RFI #: 104
Date: 4/3/2012
Job: EB-02 Keller Springs Lofts
Phone: 877-777-5115

Subject: B3 Unit Furrdowns

RFI #: 126
Date: 5/21/2012
Job: EB-02 Keller Springs Lofts
Phone: 877-777-5115

Subject: B3 Unit Questions

Subject: Electrical, TV, Telephone at Curved B3 Wall

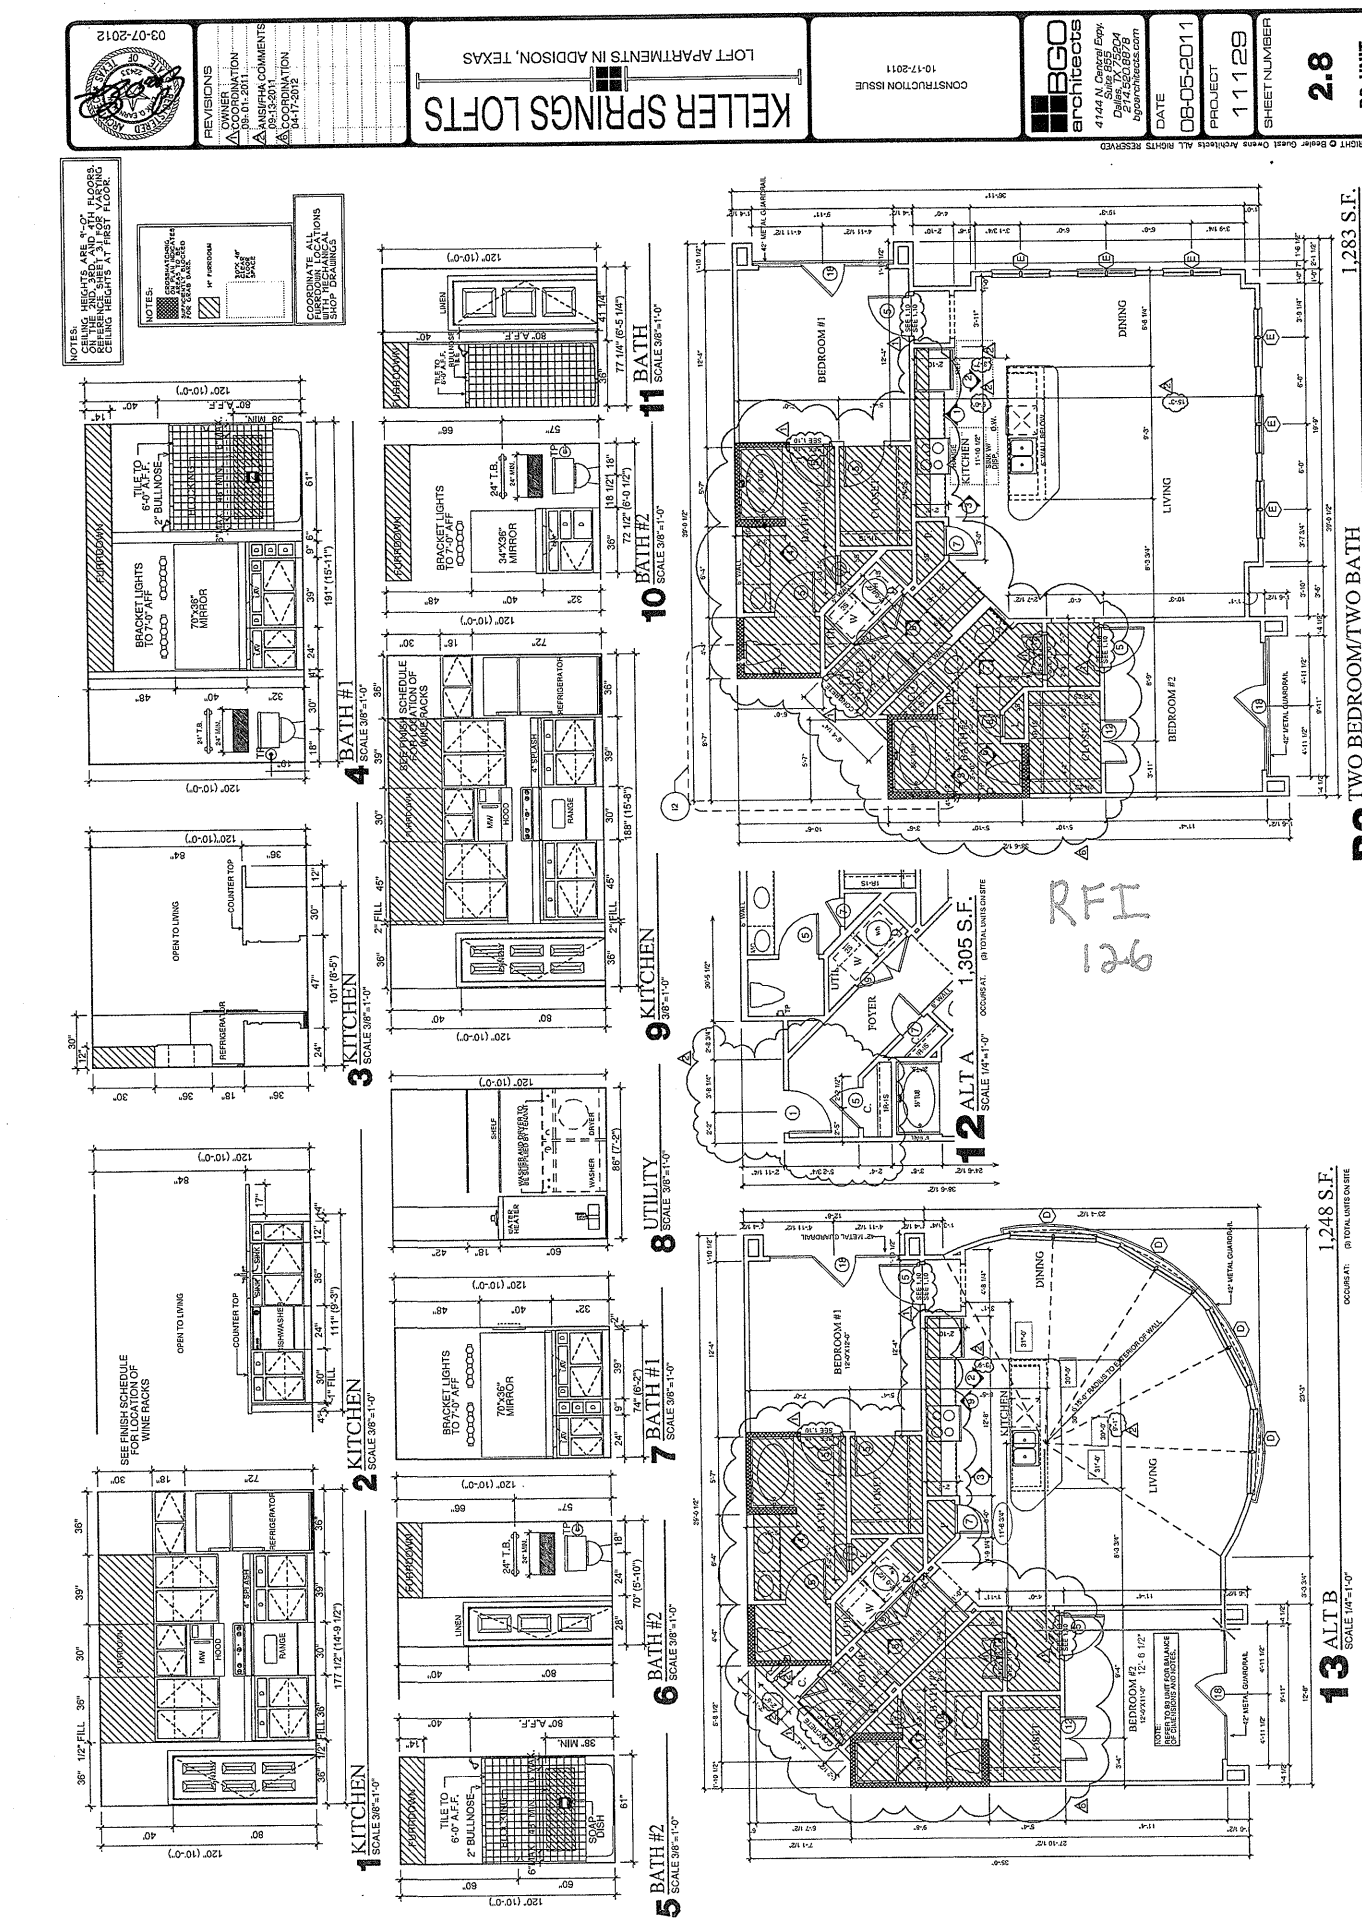
Request:
In the event that we will not have enough room between the windows (between studs) to install boxes for electrical, telephone and TV, please provide an alternate method and/or location for these boxes.

Response:
Locate the TV and data/telephone box above the electrical j-box, if there isn't enough room for side-by-side mounting.

Also, please add TV and data/telephone box in living area on common wall with bedroom #2.
